City of Ryde Submission

**Greater Parramatta and Olympic Peninsula Water
Resource Recovery Facility by Sydney Water
SSI-74258485**

**Council File reference: COR2024/135/2
Submission Date: 10 March 2026**

Figure 3: Flood Map

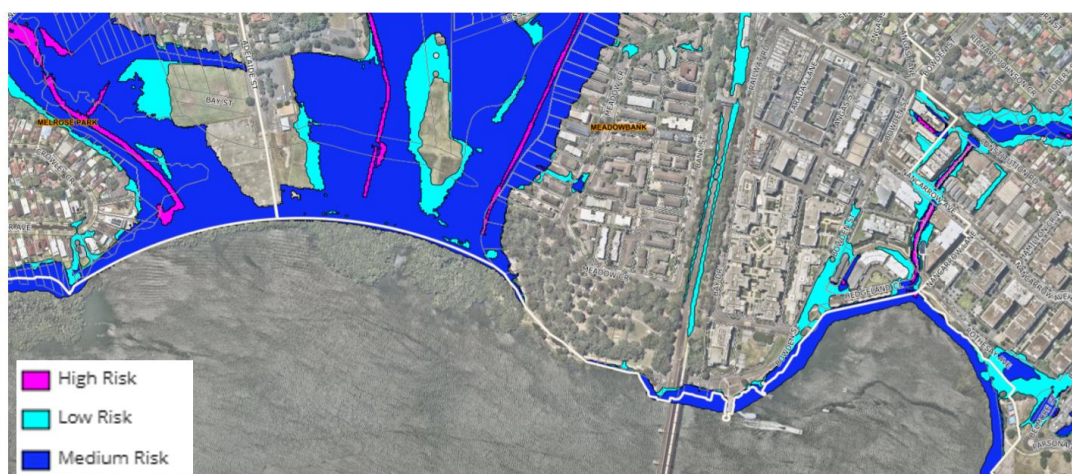
The Flood Assessment identifies that construction compounds (C28) is located within the 1% AEP flood extent and major overland flow paths, including Small Creek and Charity Creek crossings. The assessment states that potential redistribution of flows may occur, however no quantitative modelling of construction-phase impacts has been provided.

The submitted documentation identifies that Compound C28 is located within the 1% AEP flood extent with Flood depths up to 1 m expected in overbank areas with Potential redistribution of flows onto residential properties may occur. However, no quantitative hydraulic assessment has been provided to demonstrate that construction-phase activities will not adversely impact flood behaviour. In accordance with NSW Floodplain Development Manual (2023) which requires development to avoid adverse flood impacts and not increase risk to surrounding properties, Council requests the following:

1. Construction-Phase Hydraulic Assessment including:
 - A hydraulic assessment quantifying construction-phase flood impacts for the 1% AEP and PMF events, including flood depth changes,

2. Precautionary mitigation measures must be identified where impacts are predicted.
3. Detailed Construction Methodology for C28 including:
 - Temporary creek crossing design and hydraulic capacity

- Stockpile heights, volumes and locations
 - Compound finished surface levels (RLs)
 - Temporary bunding and flood protection measures
4. Construction Flood Emergency Management Plan addressing:

- Rainfall and flood trigger thresholds
 - Cease-work criteria
 - Evacuation procedures
 - Plant and stockpile relocation protocols
 - Rapid demobilisation measures

5. Preventative flood risk controls to be explored and incorporated including:
 - No permanent fill within floodplain
 - Temporary fill to be minimised and removed prior to significant rainfall events

- Demonstrate no loss of flood storage during construction
 - Scour protection and sediment and erosion control measures, as applicable.
 - No stockpiling within primary flow corridors

6. Construction compounds within flood-prone land shall incorporate the following measures:
 - Site sheds to be located outside 1% AEP where practicable

- storage of the material above 1% AEP flood level
 - No hazardous material storage within flood-prone areas
 - Usage of relocatable/ non-permanent site structures
